W.P. 42-66-12 - Township Road Underpass
2.3 Miles East of Hwy. 79
Hwy. 402, Line 'C'
District 1, Chatham

Re: Township Road Underpass,
2.3 Mi. East of Hwy. 79,
W.P. #42-66-12, Site 14-356,
Hwy. No. 402, District #1.

FOUNDATION LAYOUT

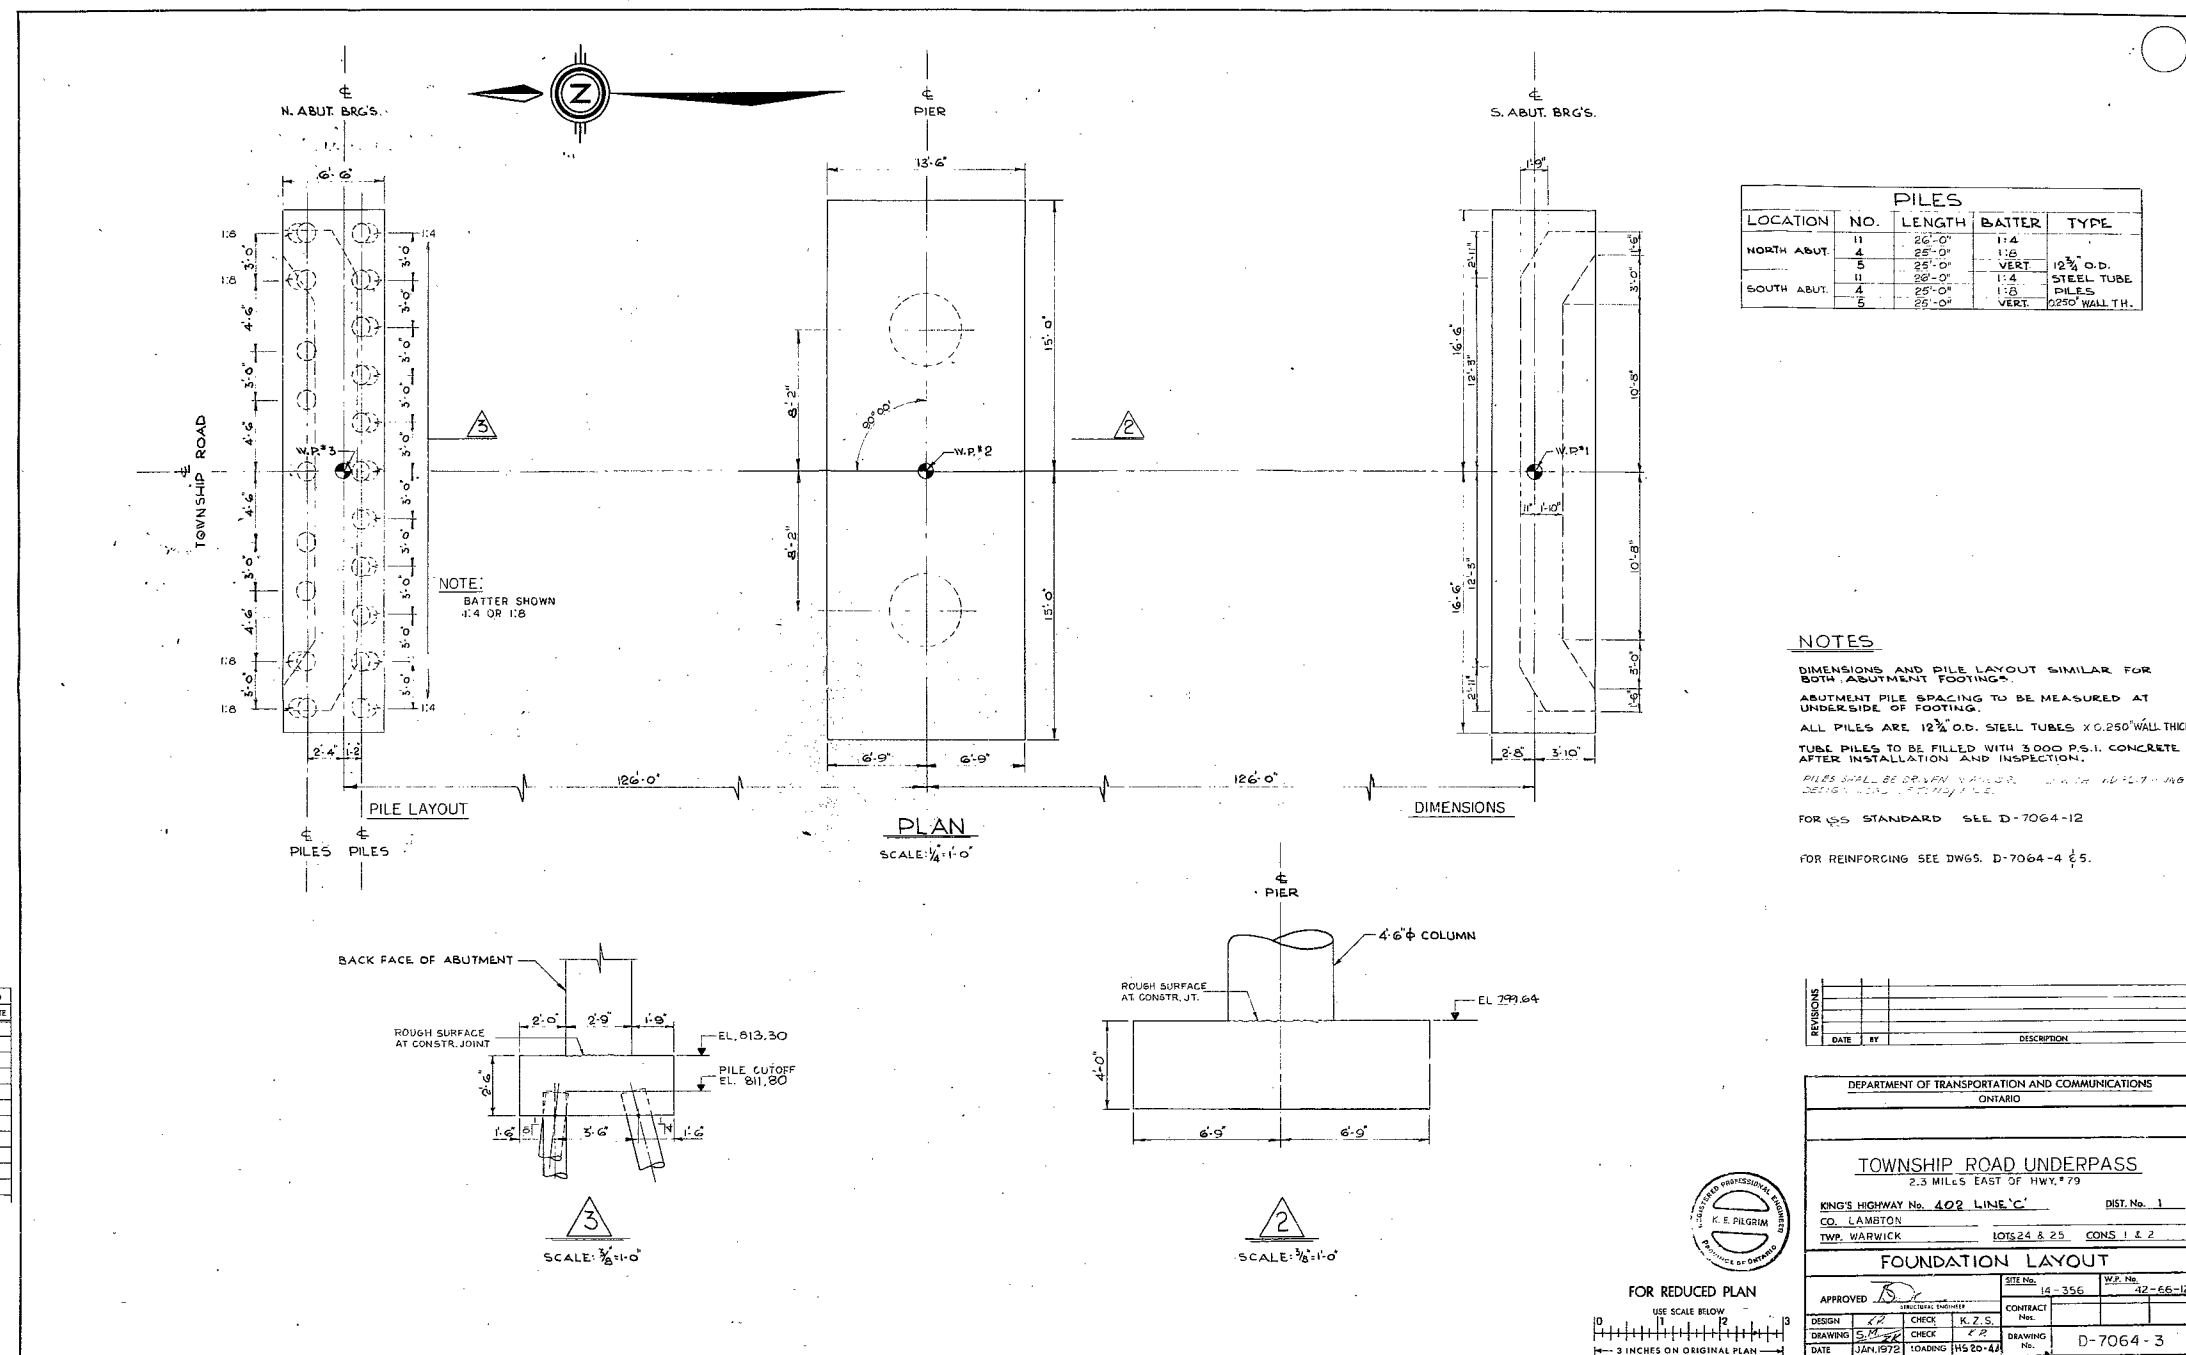
Foundation piles should not be
driven below el. 792.0 since the soil strength
decreases with depth below this elevation.
